BUTTE REGIONAL TRANSIT OPERATIONS CENTER

Tenant Improvement

ADDENDUM NO. 1

1/4/2016

ELECTRICAL POWER PLAN

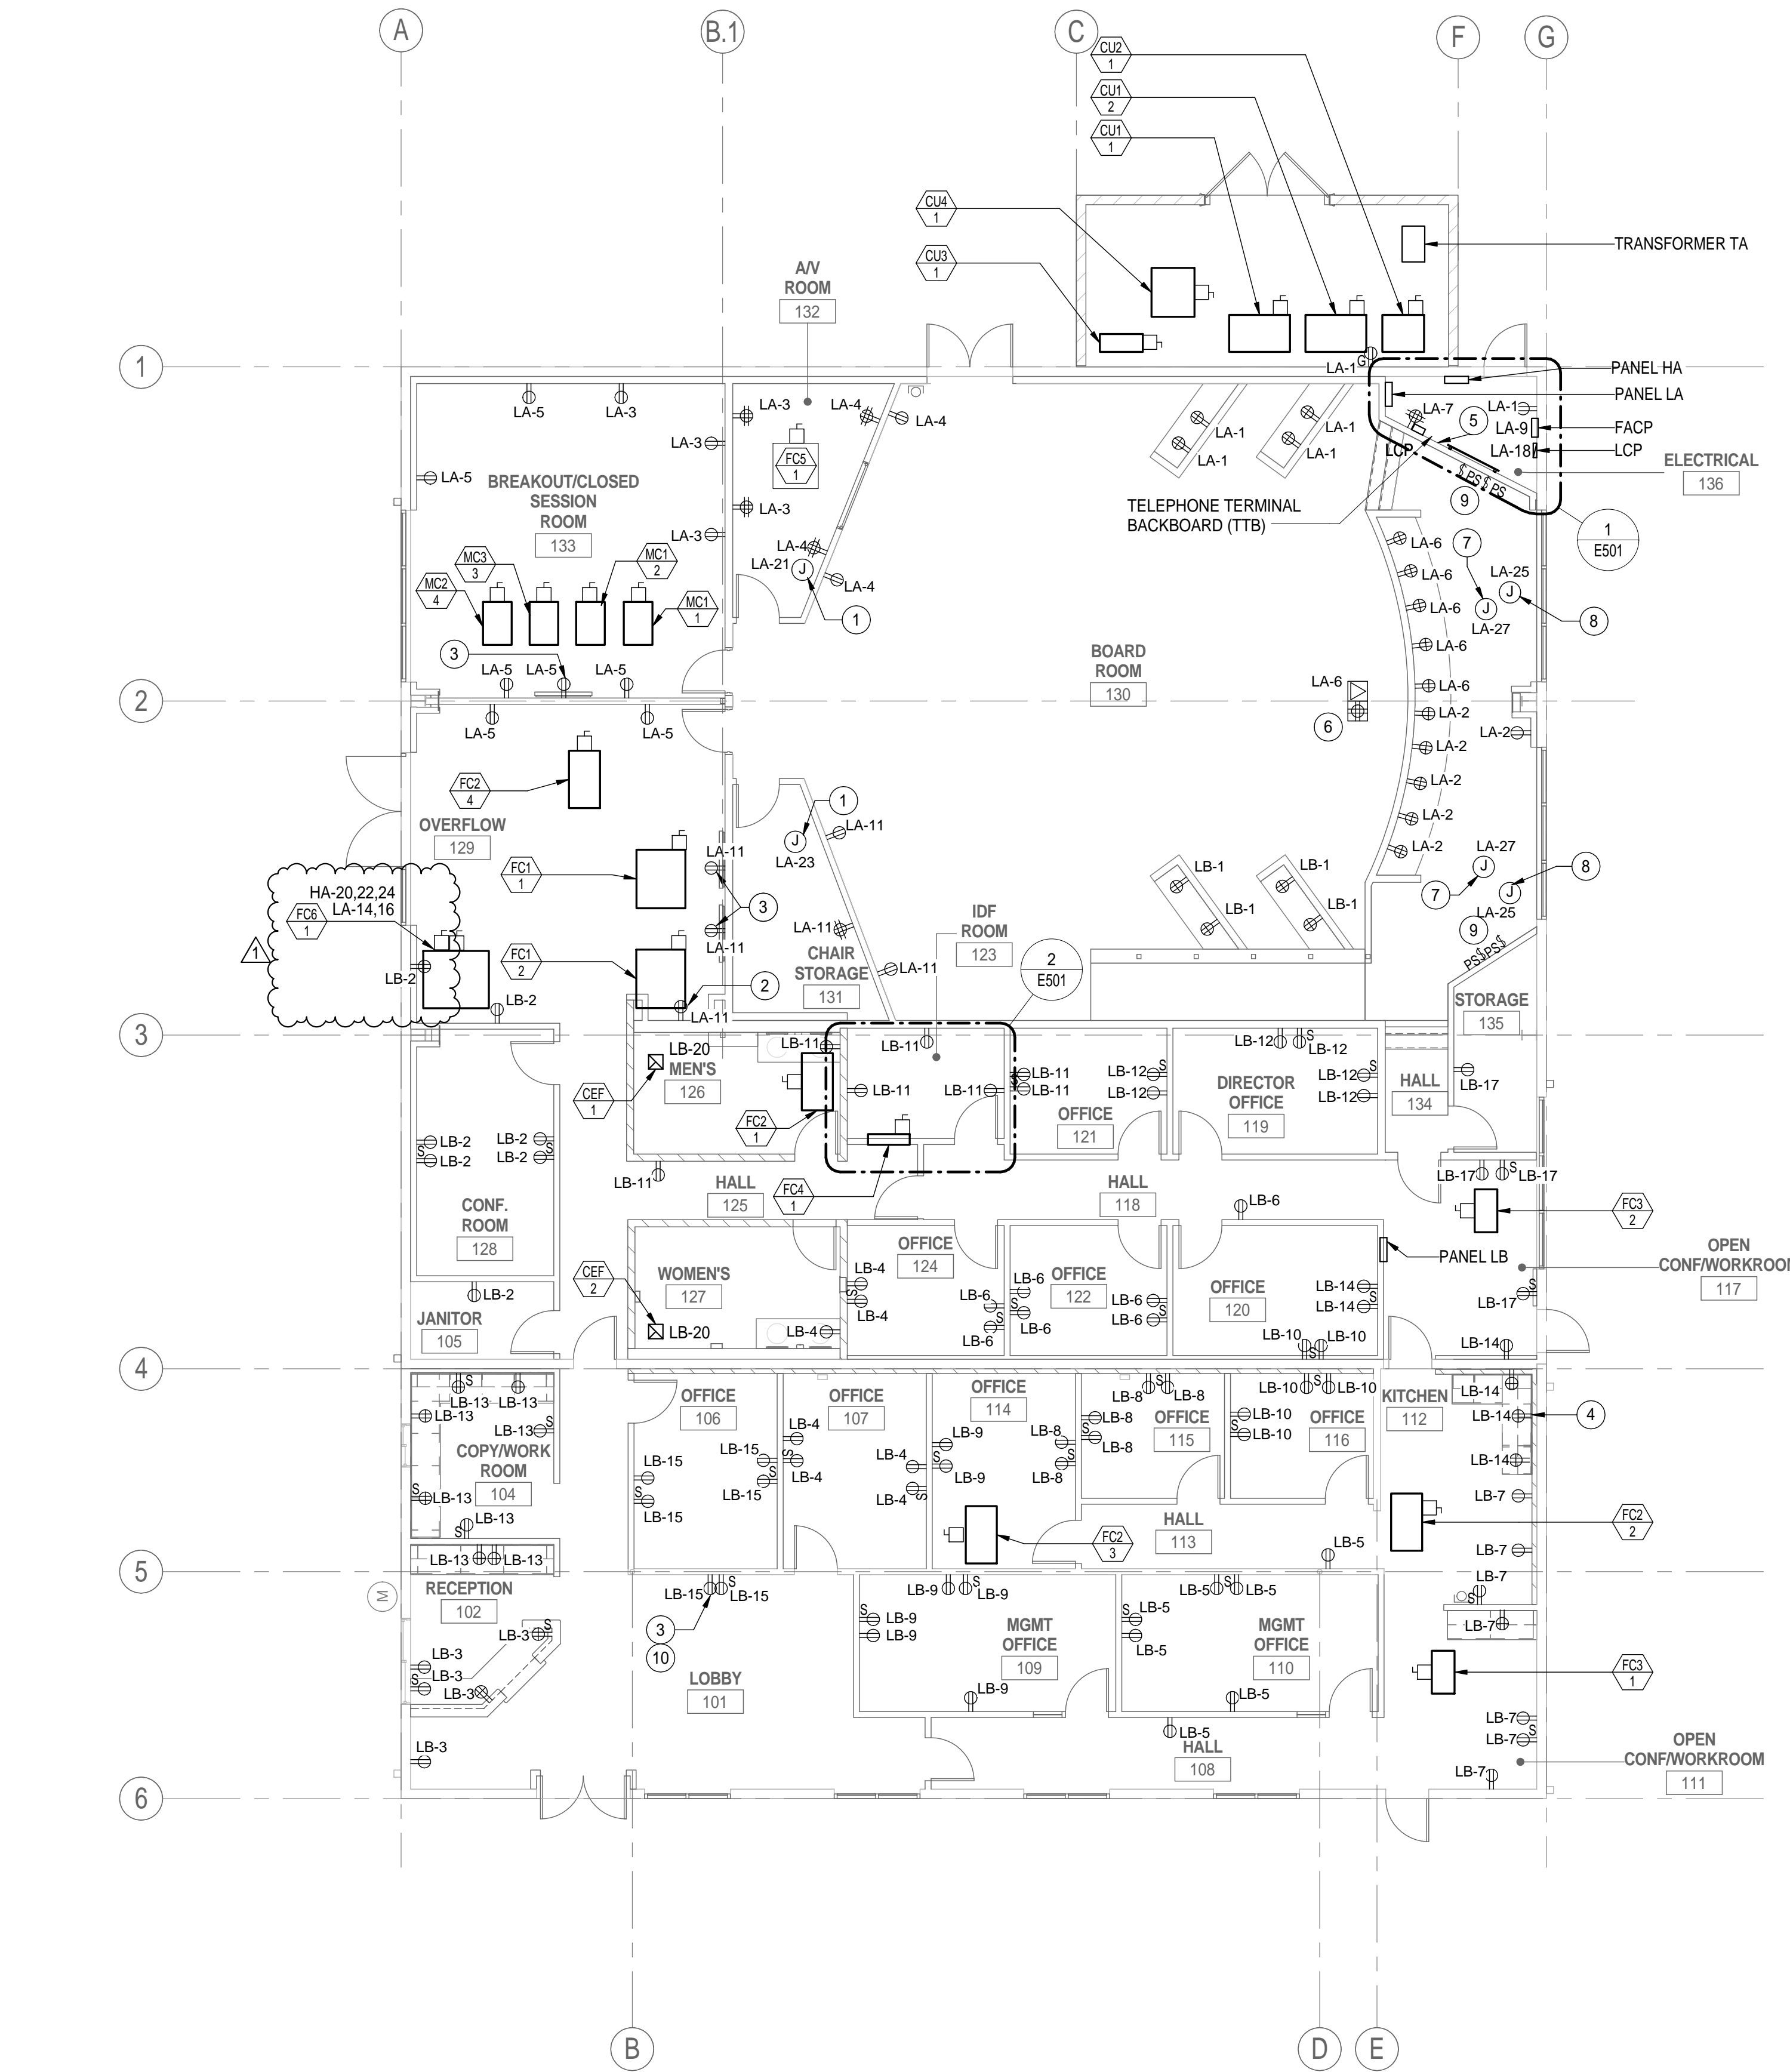
1.14 REVISION TO DRAWING E201 – ELECTRICAL POWER PLAN

- a. Revised HVAC Electrical Schedule – FC6-1 Fan and Strip Heater Specifications

SHEET TITLE:
MECHANICAL PLAN

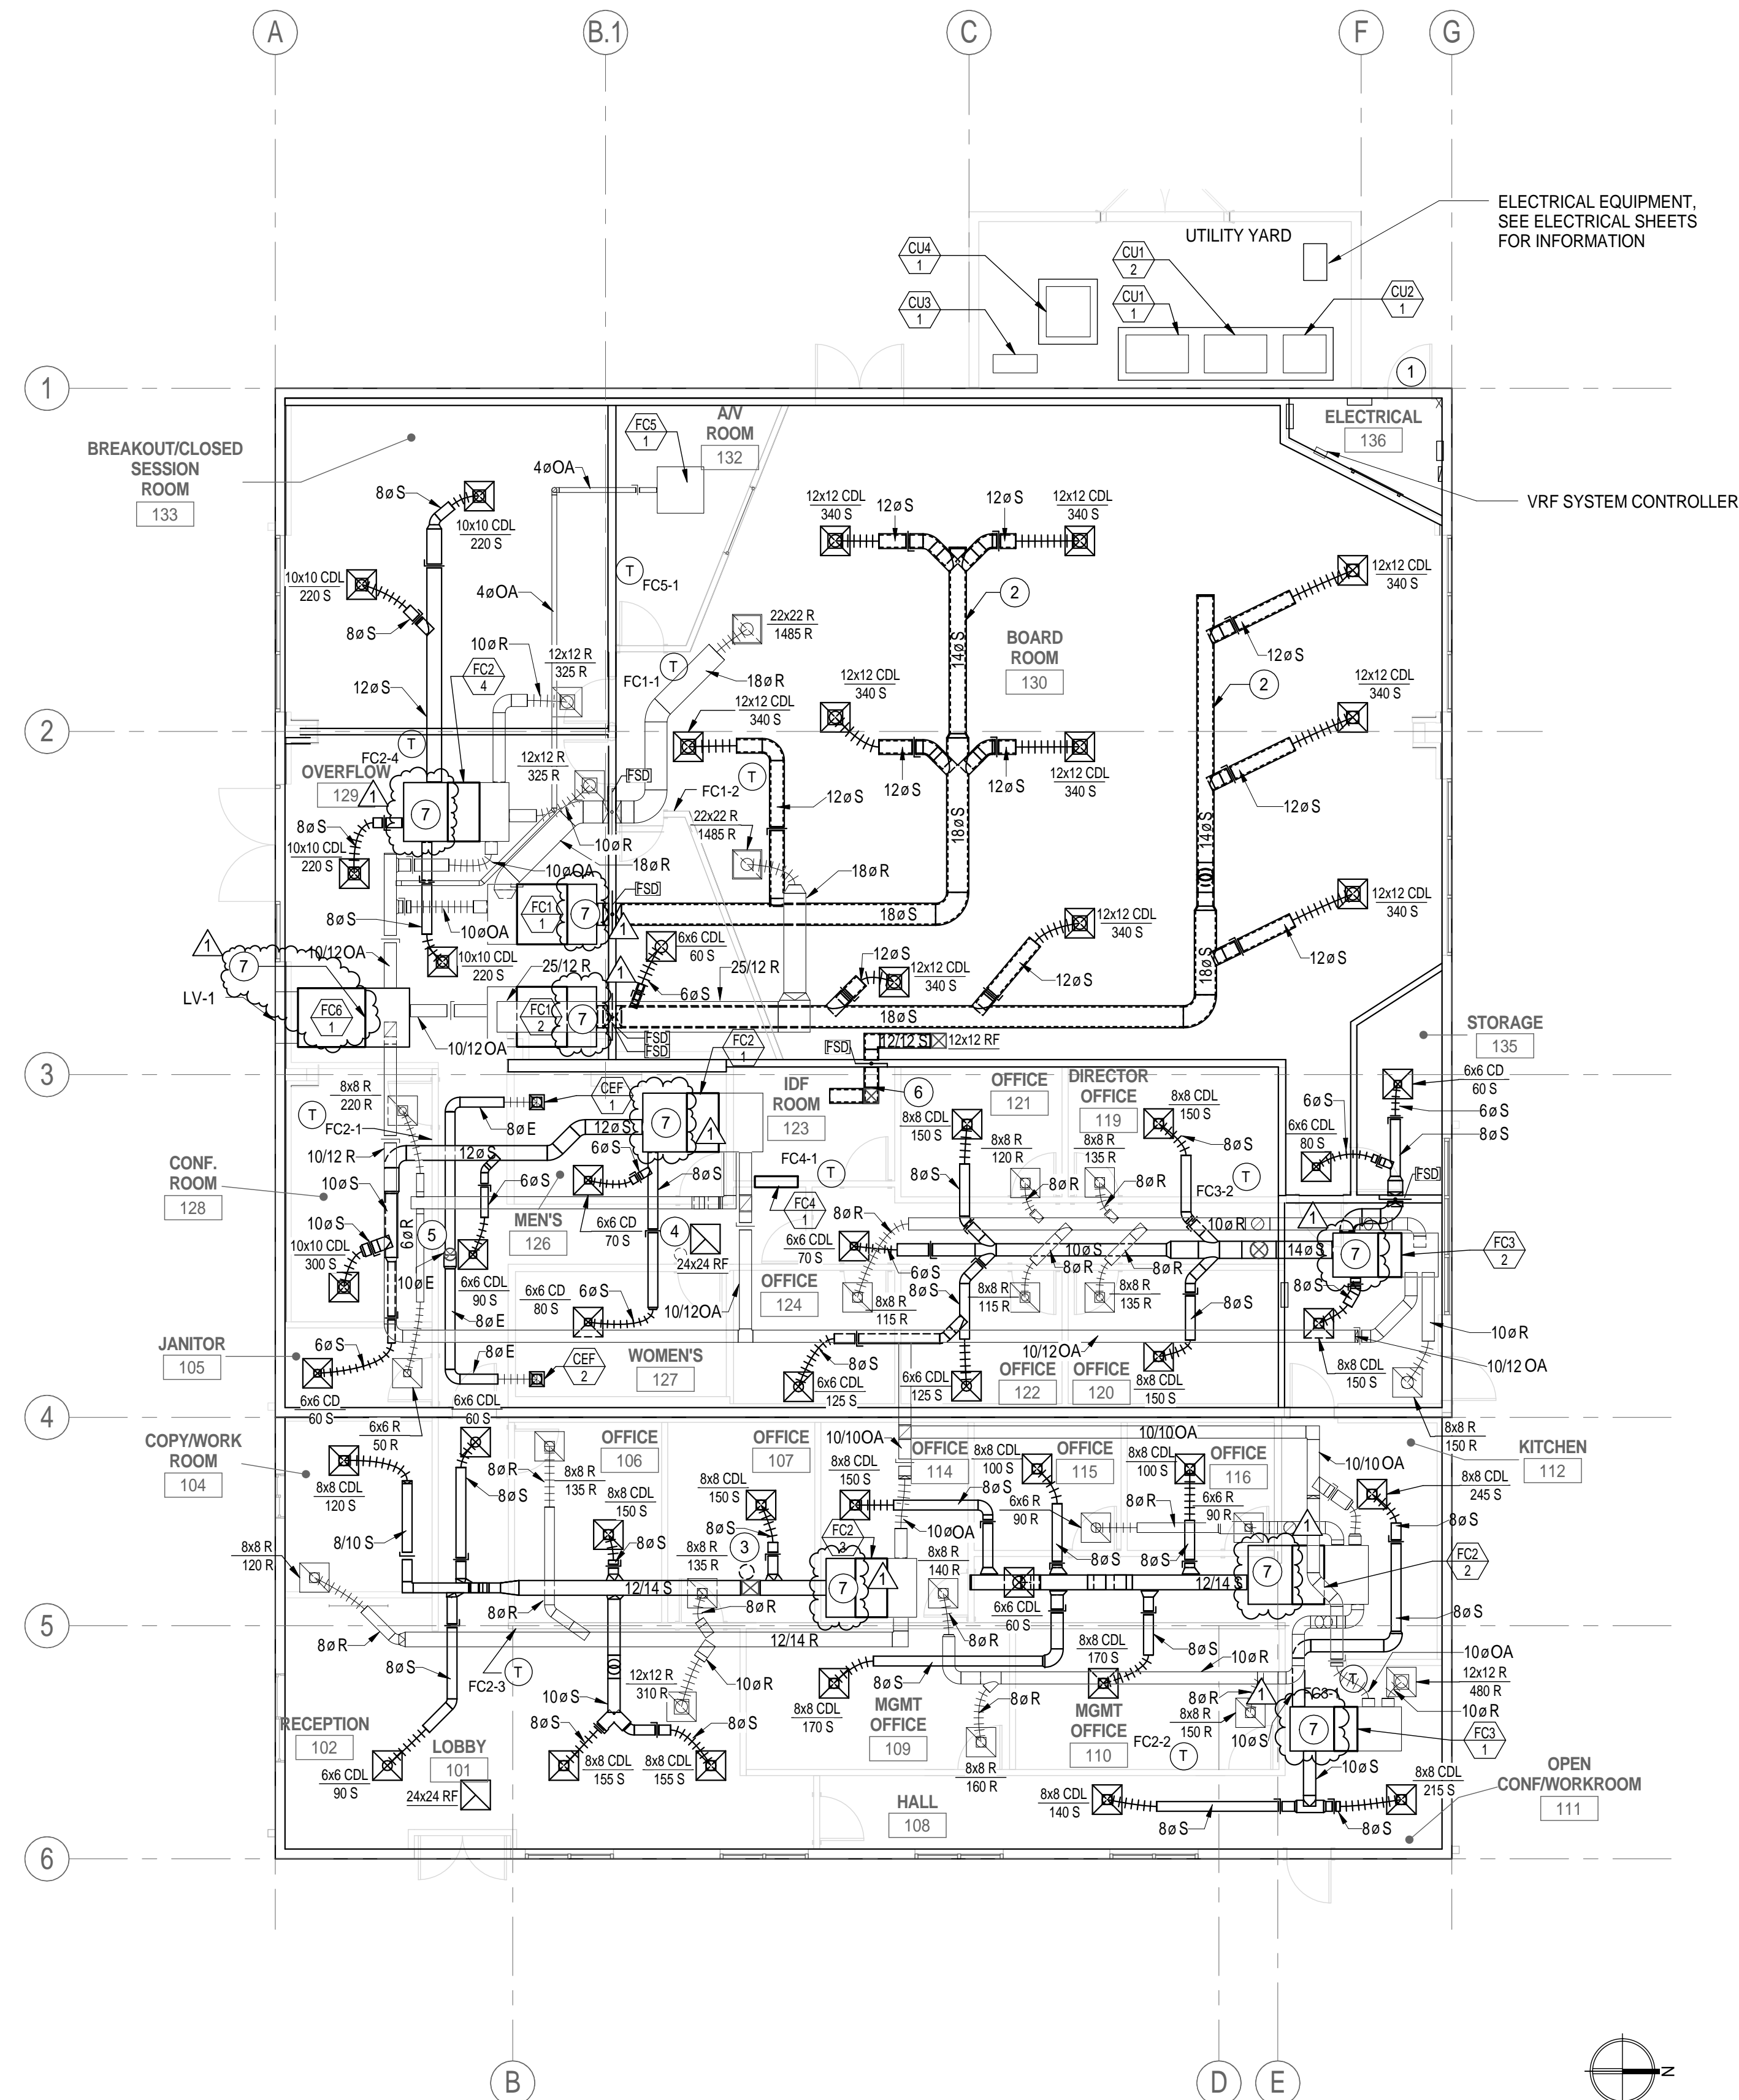
- 1.12 REVISION TO DRAWING M201 – MECHANICAL PLAN
 - a. Added Keynote 7 – INSTALL DUCT SMOKE DETECTOR IN THE SUPPLY AIR SECTION OF THE UNIT
- 1.13 REVISION TO DRAWING M801 – MECHANICAL SCHEDULE

1.16 REVISION TO DRAWING M201 – MECHANICAL PLAN

- a. Added Keynote #7: Install fire smoke duct detector in supply air section of the unit.

PLUMBING FLOOR PLAN
WITH PLUMBING
FIXTURES LOCATED

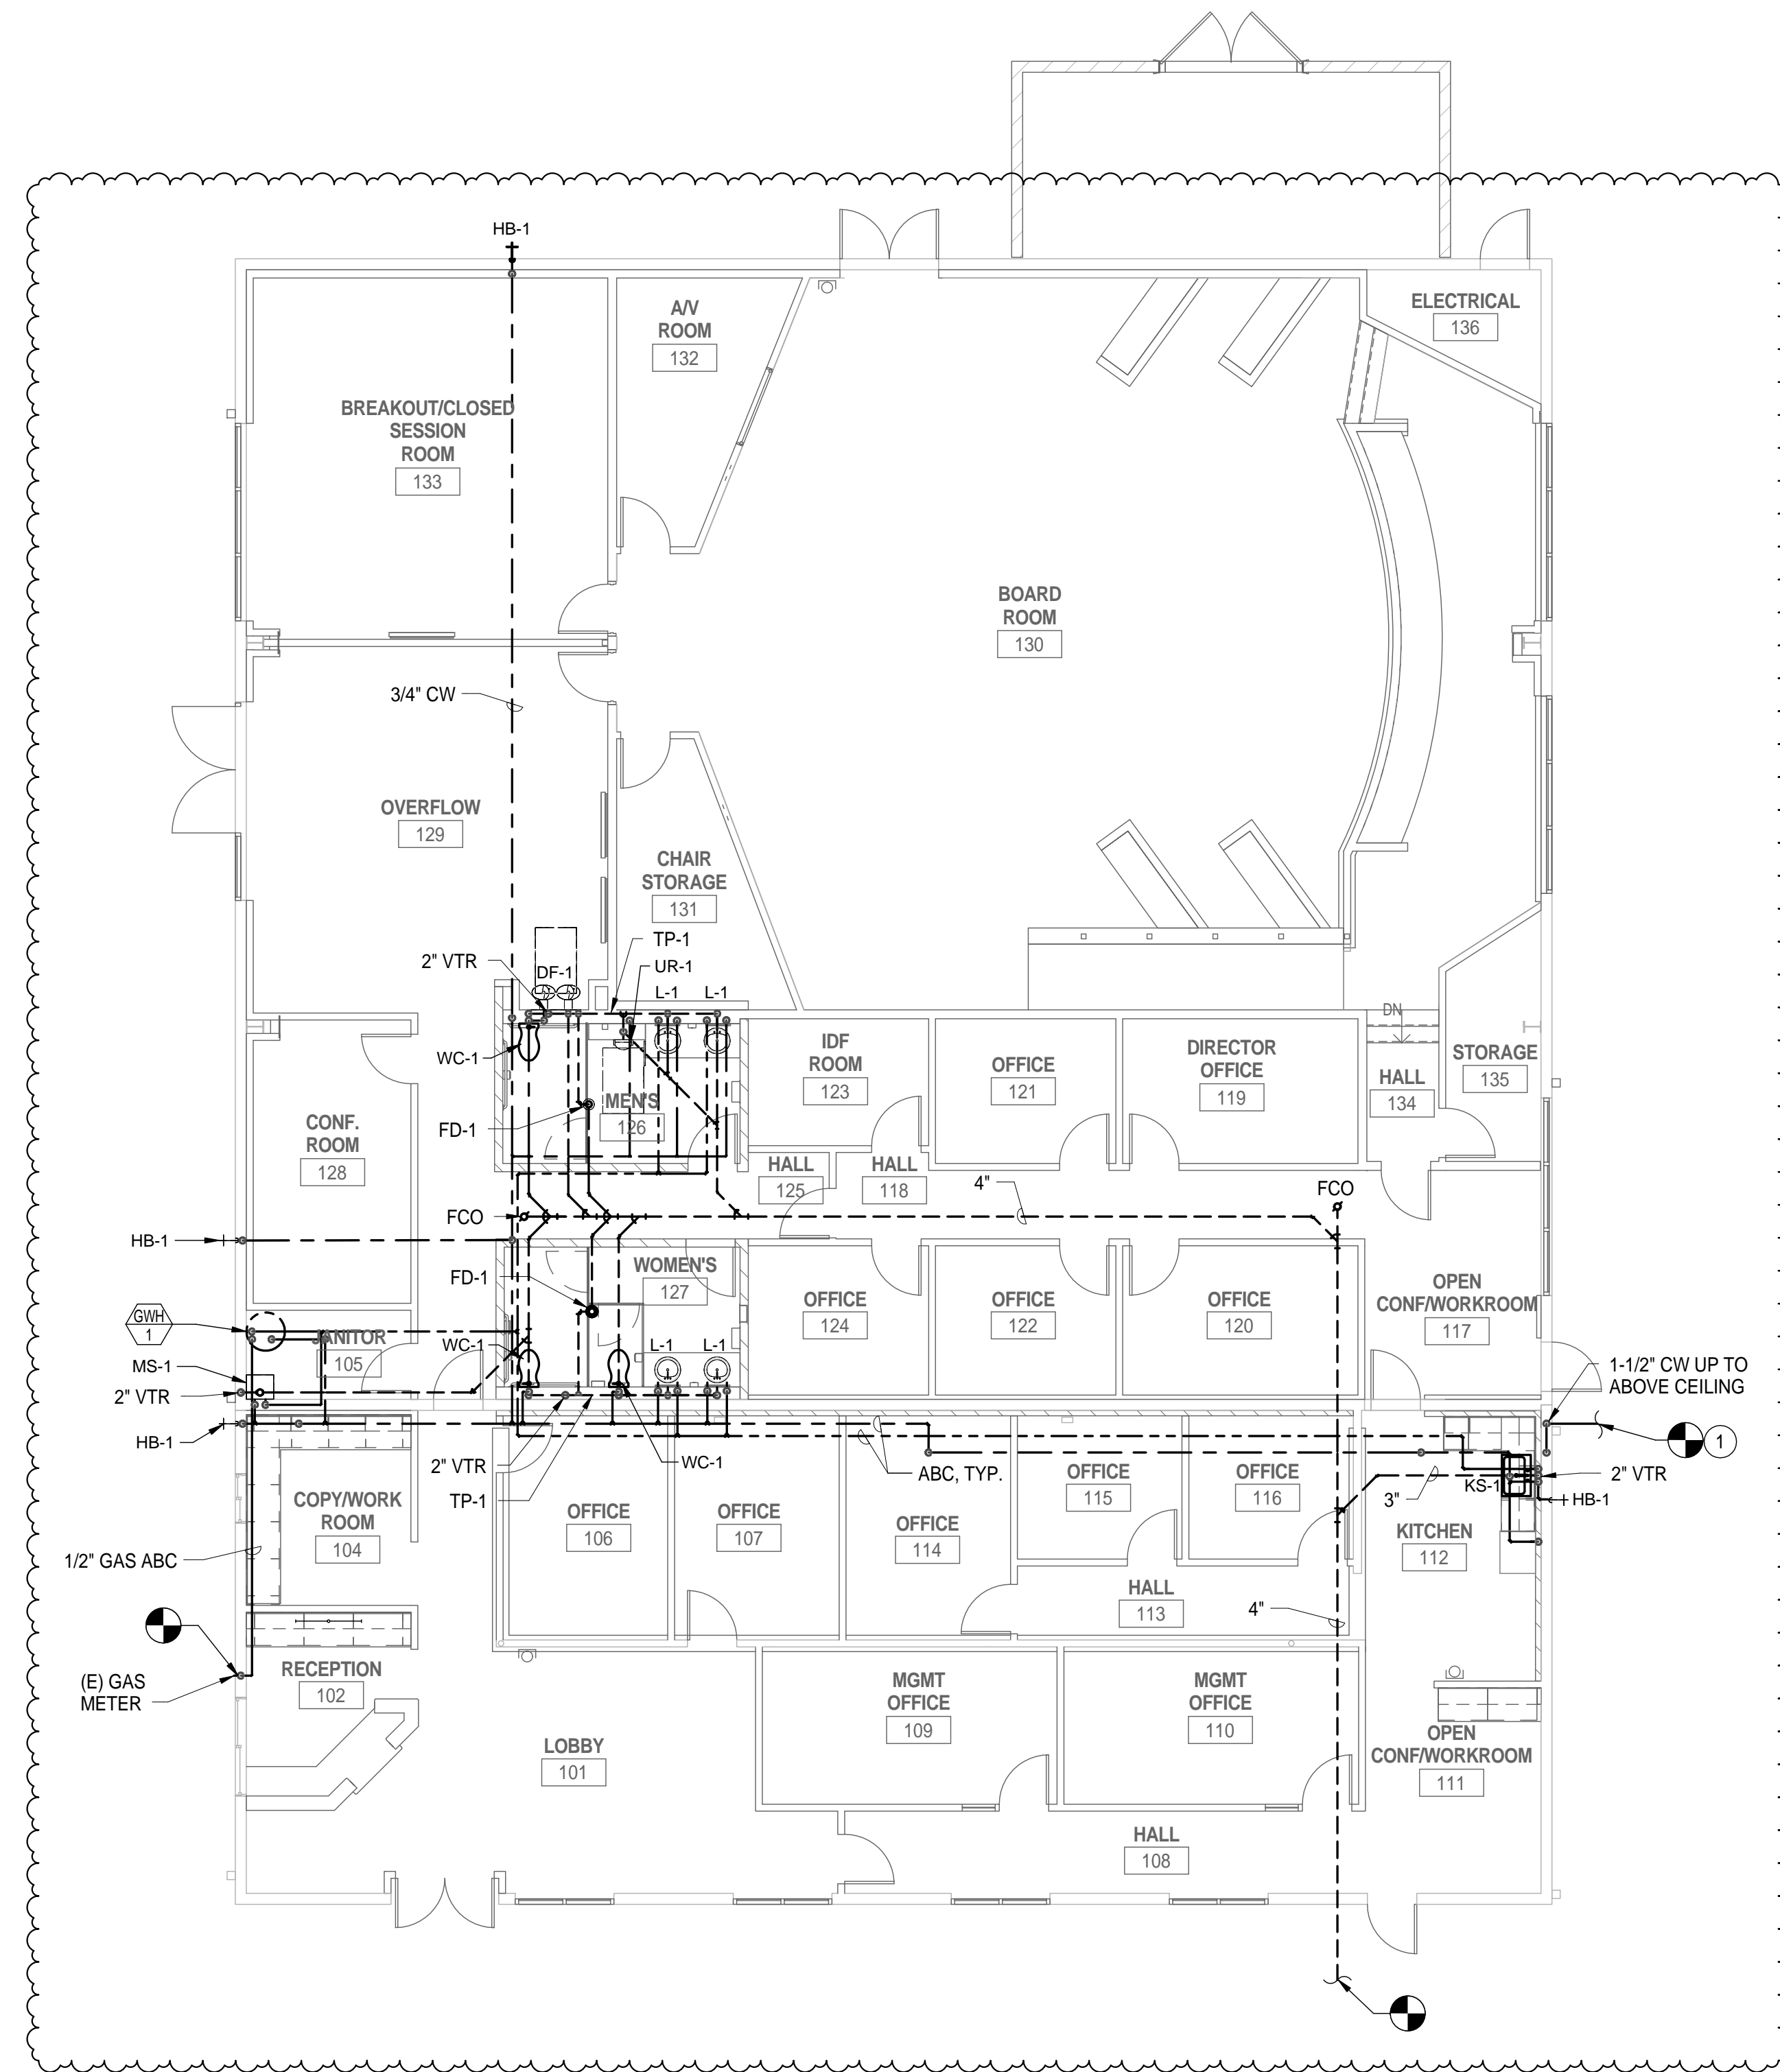
1.18 REVISION TO DRAWING P201 – PLUMBING FLOOR PLAN

- a. Revised plumbing plan for routing clarification.
